JOINT REGIONAL PLANNING PANEL (Sydney East Region)

JRPP No	2015SYE030
DA Number	14(68)
Local Government Area	City of Botany Bay
Proposed Development	Integrated Development – Amended application seeking approval for the redevelopment of the site for residential purposes; comprising the erection of a mixed use development comprising of 3 residential flat buildings ranging in height between 3 to 8 storeys, containing 313 residential apartments, 2 commercial tenancies, and basement car park for 552 spaces. An offer to enter into a Planning Agreement under S93F of the <i>Environmental Planning and Assessment Act, 1979</i> accompanies the development application. The offer includes, the dedication of the 3270 m² park located off New Street 2, dedication of a north-south through-site link and associated public domain works; and associated offsets from section 94 contributions.
Street Address	16 Pemberton Street, 8 Pemberton Street, 14 Pemberton Street, and 12 Rancom Street, Botany; known as Parkgrove West.

Recommendation	Refusal
Report by	Wil Nino, Consultant Planner, City of Botany Bay

Figure 7: Indicative location of infiltration trench shown hatched, to service Building E and F

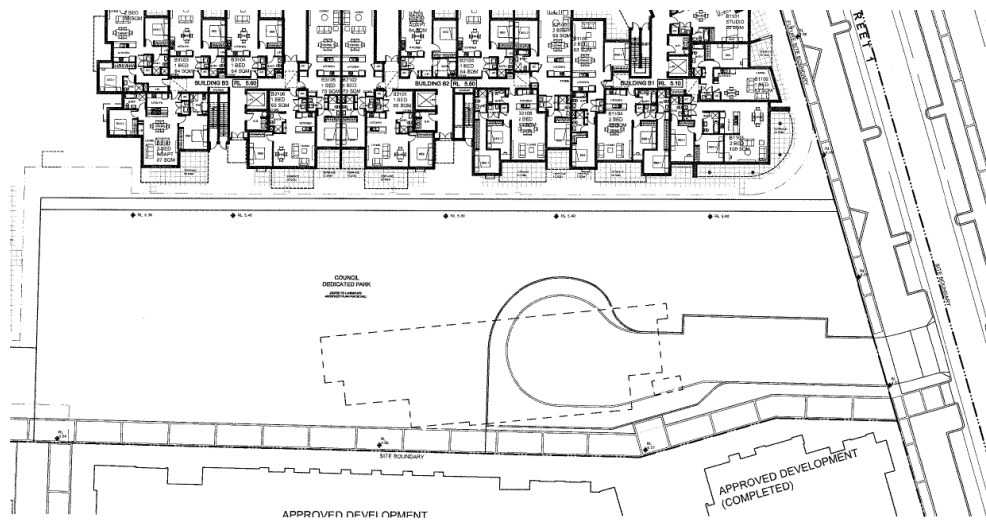
However, it should be noted that whilst the public park is identified as being located on deep soil, the developer has constructed two stormwater infiltration systems with and

without out Council approval under portions of the land that form part of the park to service the adjoining Building D, E and F at Parkgrove East. One of the infiltration trenches (associated with Buildings E and F - unapproved) is shown in the following image. The other trench is located underneath the proposed north-south link portion. This diminishes the ability to provide tree planting in a large portion of the park.
